5-03	ADDITIONAL IMPROVEMENTS		COUNTY OF ORANGE INTEGRATED WASTE MANAGEMENT DEPARTMENT	
			OLINDA ALPHA LANDFILL	
		EXISTING ACCESS ROAD IMPROVEMENTS		
		PLAN VIEW		
		DESIGNED A.C.R./C.H.M.		SHEET
		DRAWN J.P.J.		4
		CHECKED M.A.C.		OF 8
		SCALE AS-SHOWN		
		DATE 1-2003		
		DRAWING NO. 20002DB.DWG		
		DATE

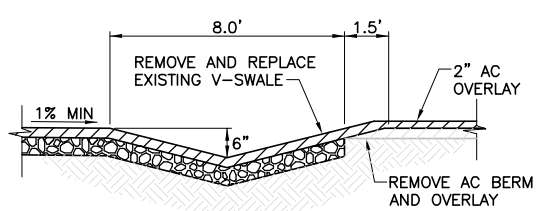
NO DRAINAGE CUTOUTS SHALL BE PLACED IN THE AC DIKE BETWEEN STATIONS 35+00 TO 40+00

STA 36+70 END (DELETED)

STA 35+30 BEGIN
